# ADDENDUM 1

Tennessee Tech University – Walton House

ROBERT WAITS – STUDIO TOPOGRAPHY (ST)

## ADDENDUM 1 – Questions and Responses

L100

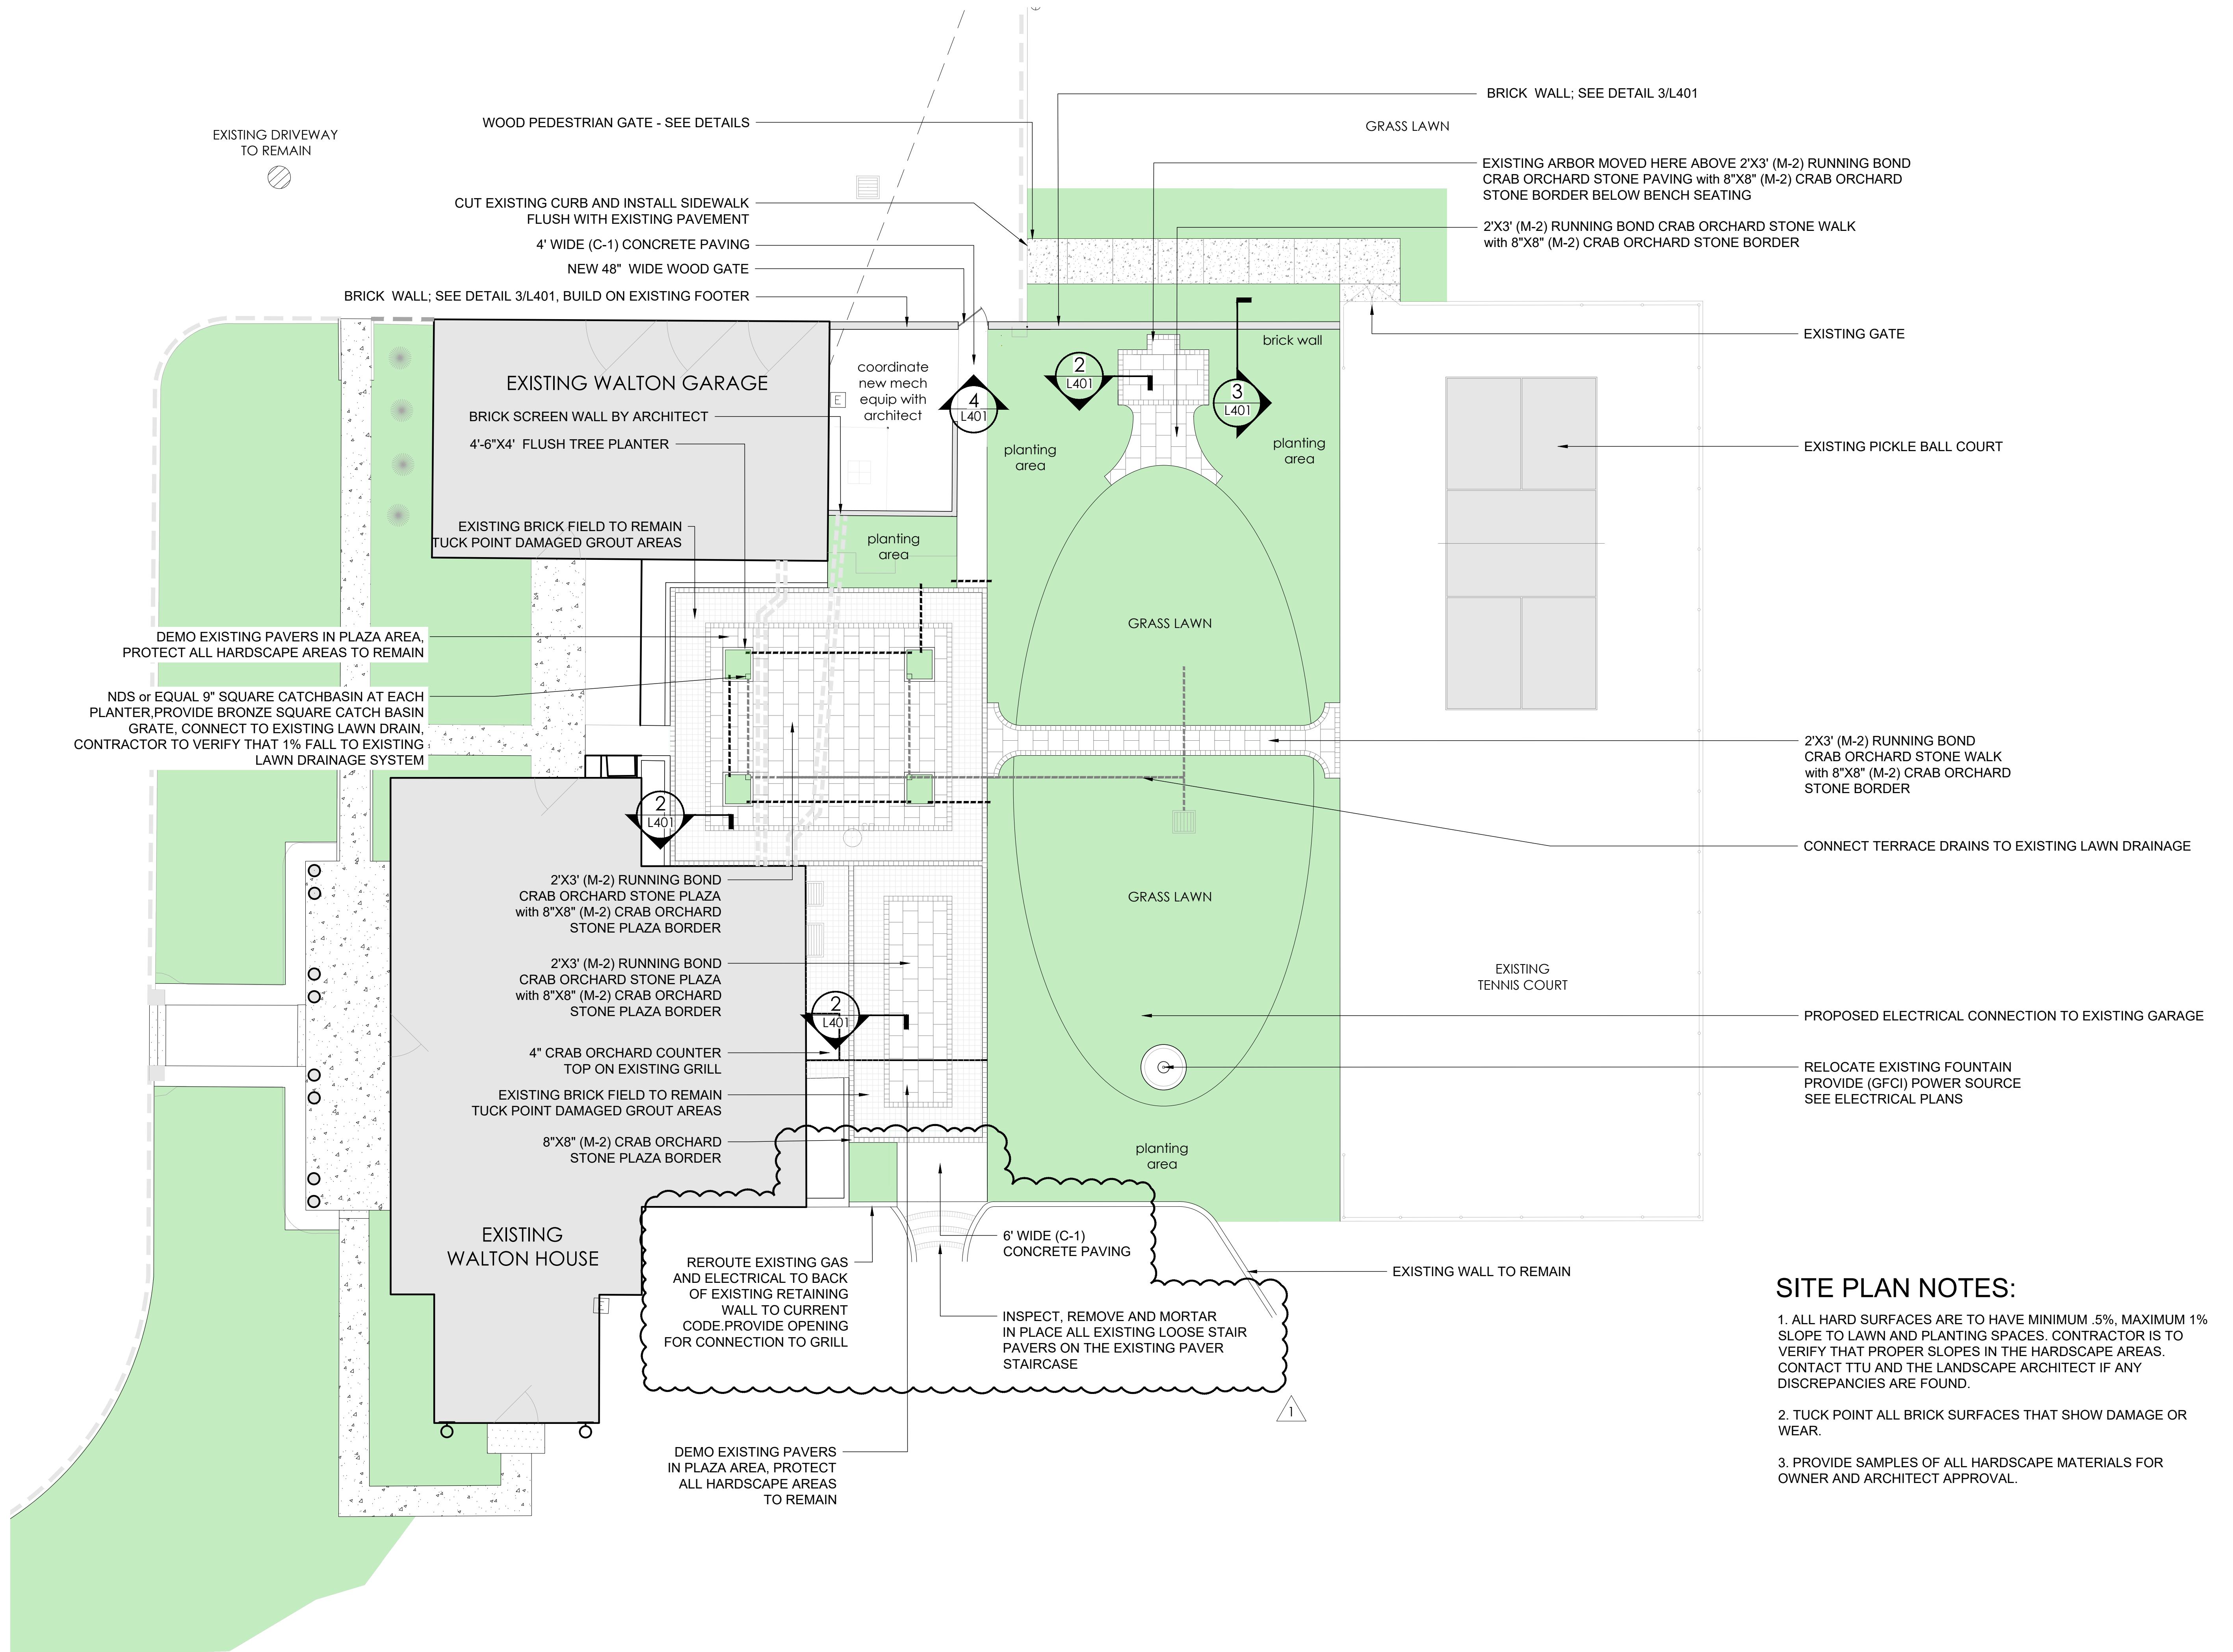
2. Is crab orchard stone polished or natural?
  - a. **ST Response – Natural Finish**
3. L110, The area noted with 'L', at the bottom of the page L110, this is stair pavers to the pool area. Dr. O has requested to repair some step in this area. See photo attached.

- a. **ST Response – Bid as shown on existing E1.1 drawing.**
10. New note: Existing power and gas at the low wall to be rerouted to the inside out of sight. The concern is it may not be to code. See photo below.

L100 – Note for Stair Correction, Revised Layout, Existing Gas and Electrical Relocation Note

- a. **ST Response – See revised Comment on L100 referencing stair maintenance**
4. L401, Is the brick wall 6'-0" at the tallest location or will it increase with the grade? How wide is the wall?

- a. **ST Response – See revised note on Sheet L100.**
11. L503. The planting sizes... is this the size required at the time of installation?
  - a. **ST Response – Correct, the sizes are required at planting**

L600

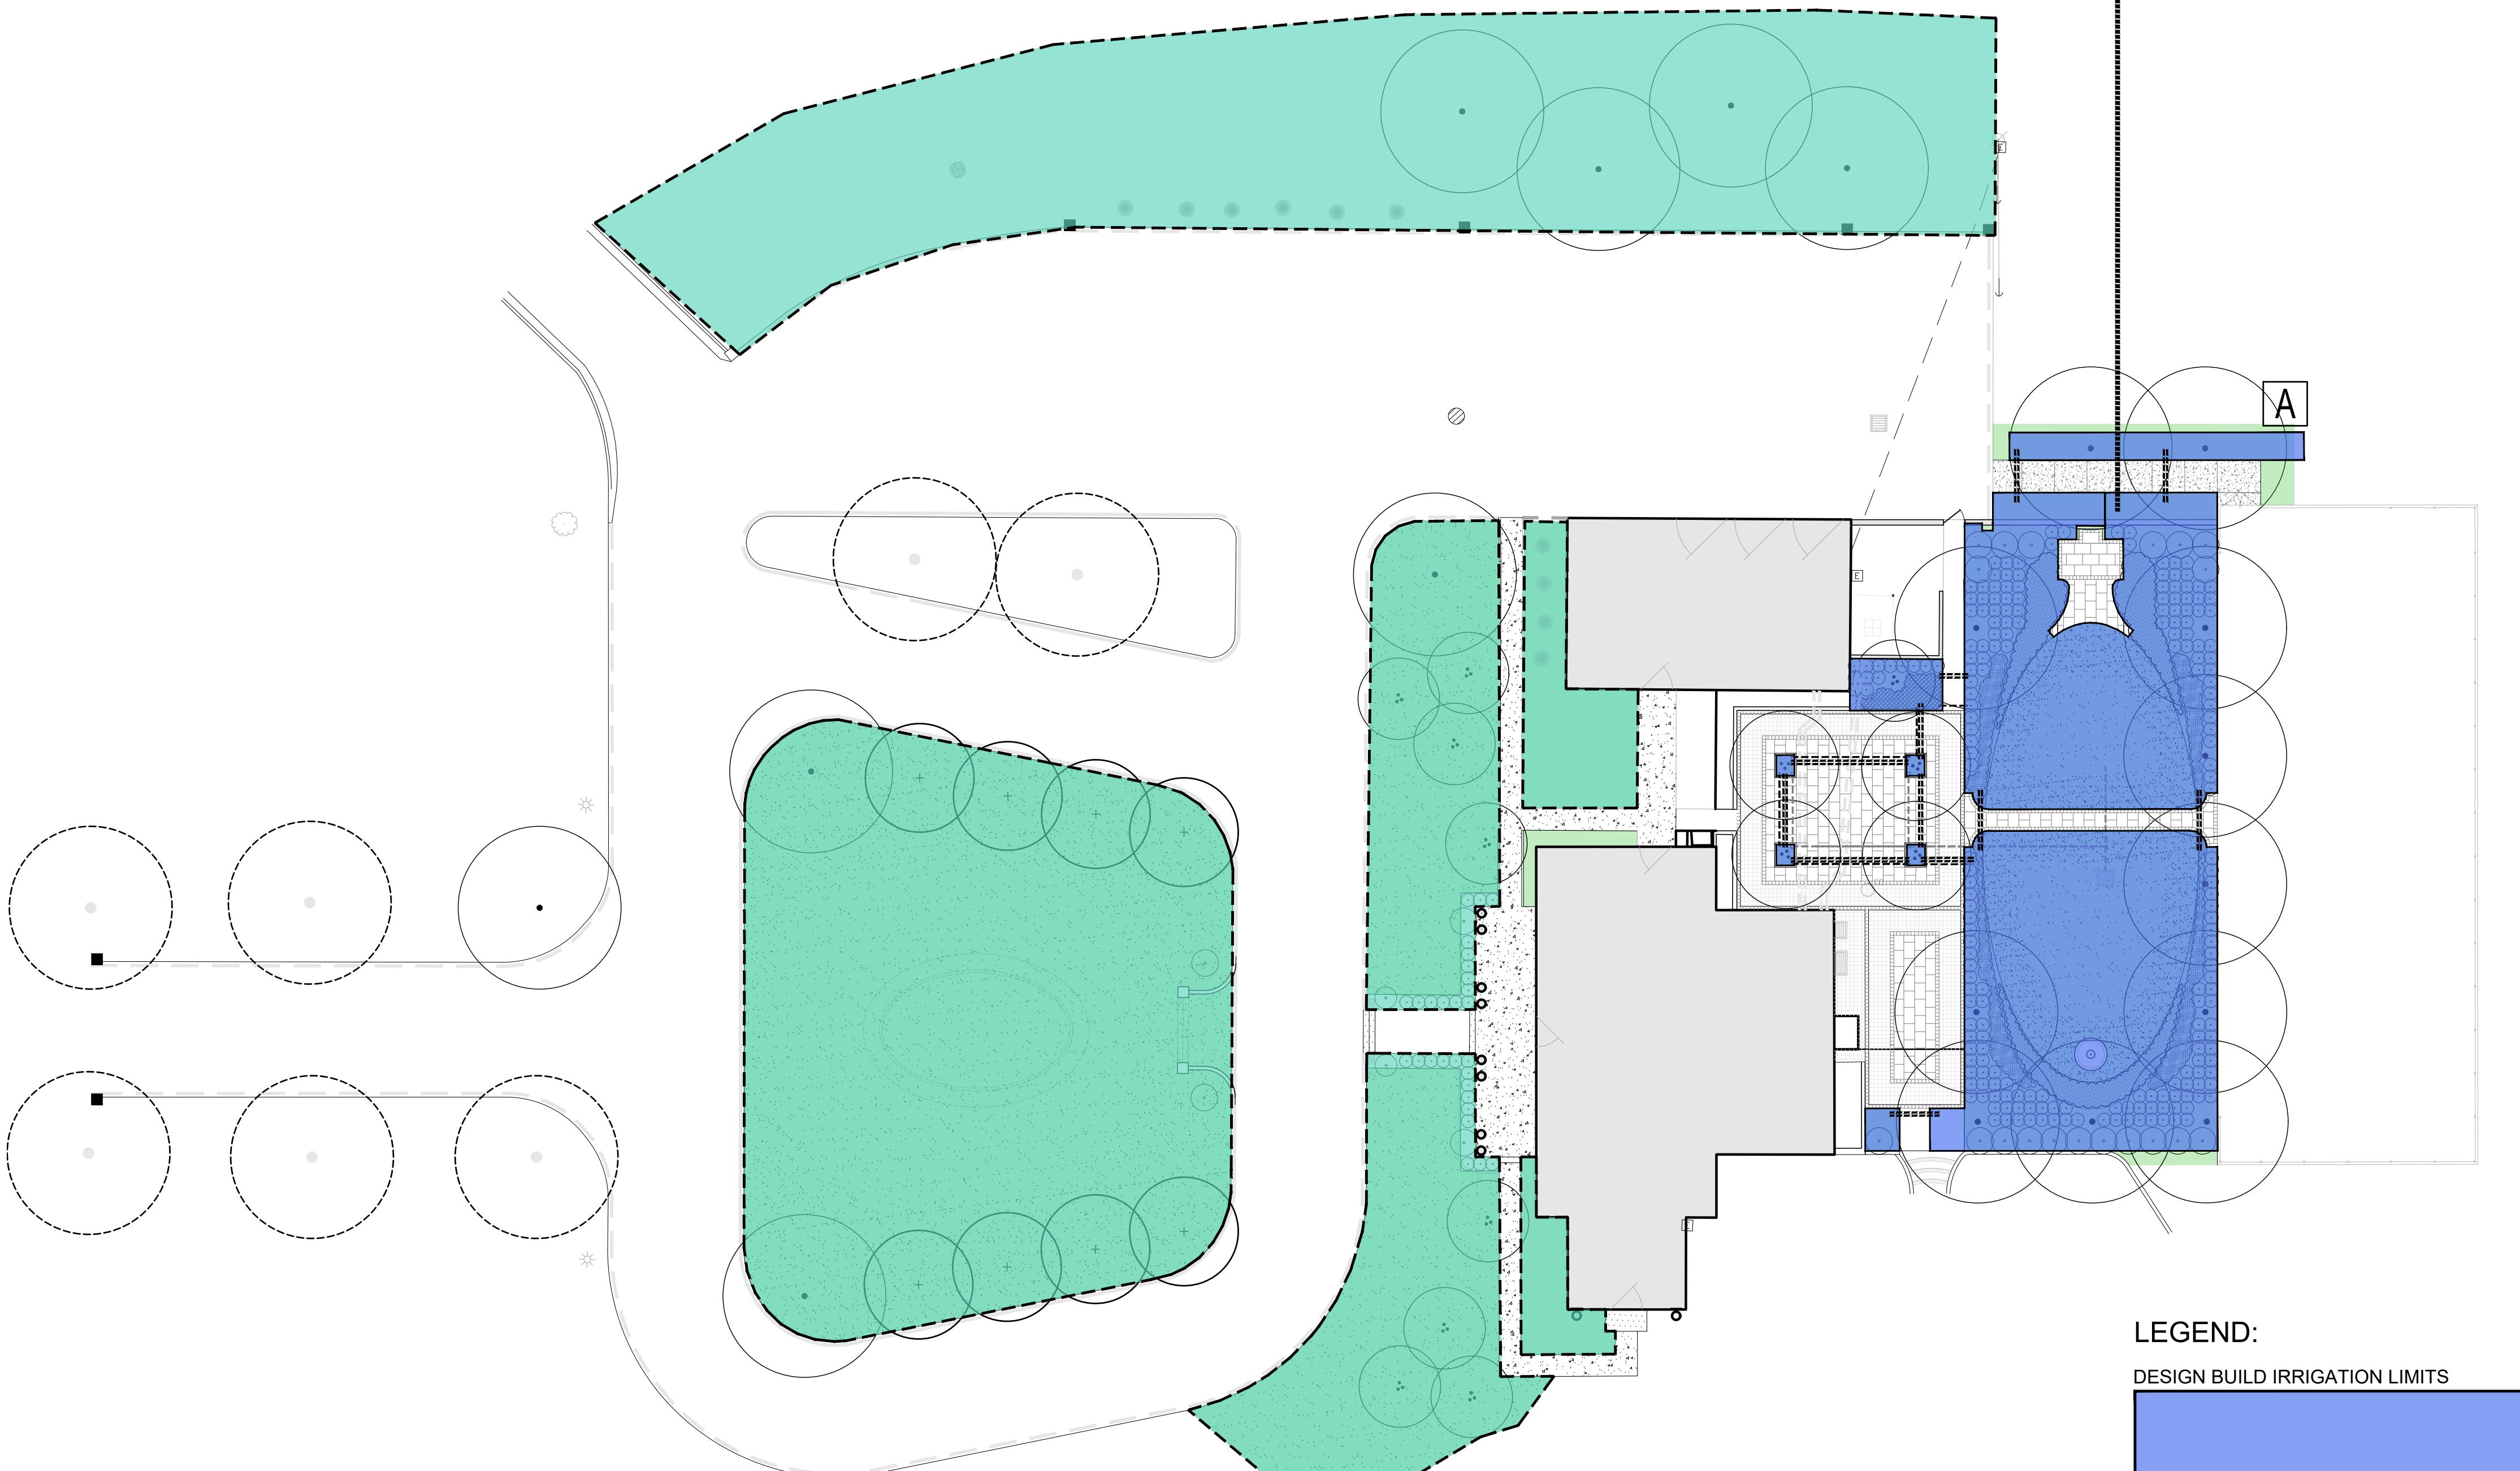
- a. **ST Response – Wall is to be 6' tall at the low end and decrease in height. Top of wall is to stay level.**
5. L501, Consider adding irrigation to the alternate for the planting in the front yard. Is a new sod lawn part of the alternate?

L600 – Additional Addendum 1 Irrigation Area

- a. **ST Response – See revised Sheet L600 for Alternate 1 Irrigation Area.**
6. Will the new trees be staked? Will sod be planted up to the trees or mulched around?
